BANBURY PHASE 3, LAND TO THE NORTH-EAST OF JUNCTION 11, M40 - BANBURY, OXFORDSHIRE:

PROPOSED MIXED-USE DEVELOPMENT

REVIEW OF TRANSPORT ASSESSMENT

REVIEW DATE: 13TH SEPTEMBER 2021

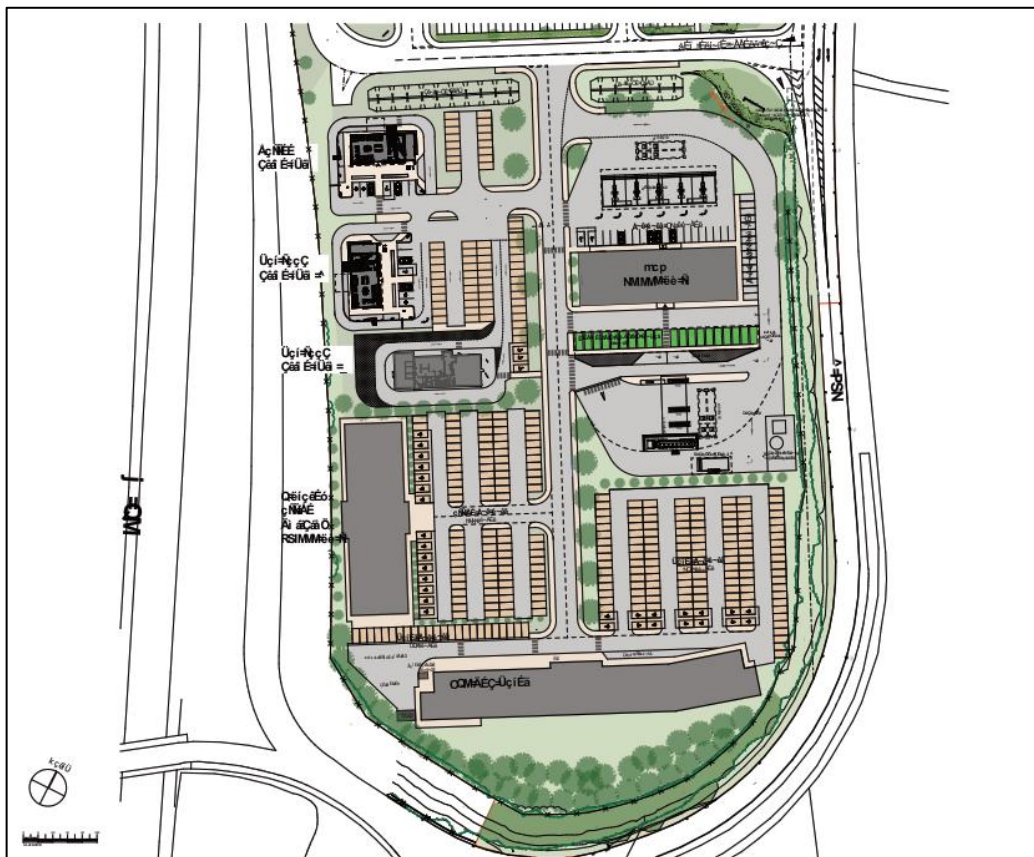
The mixed-use development includes a 240-bed hotel, a 5200sqm office building, PFS, coffee and hot-food drive thru. For information, the indicative Masterplan below and as per Appendix B has a labelling error.

The internal estate road is 7.3m with 2m wide footpaths either side. No SWEPT path analysis to show large vehicles, including buses, can manoeuvre safely on site was provided. Please supply the swept path analysis exercises.

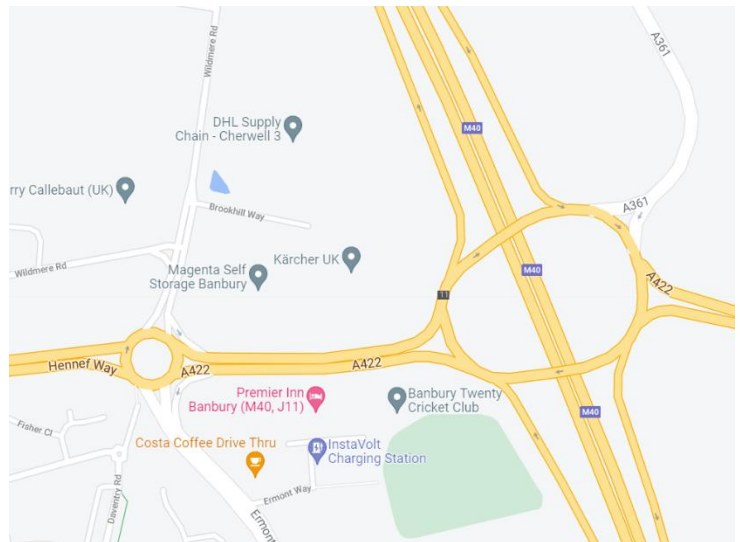
Junctions 2, 3, 4 and 5 are signalised, but without the current signal information and junction drawings, no review to confirm findings, i.e. over capacity in 2026 and 2031 with and without development, is possible. It is claimed that given the marginal extra impact of the proposal, no mitigation is required.

WNC Comment 6: Final comment regards junction capacity assessment results and mitigation can only be made once the models can be reviewed in detail with provision of current signal information and junction drawings.
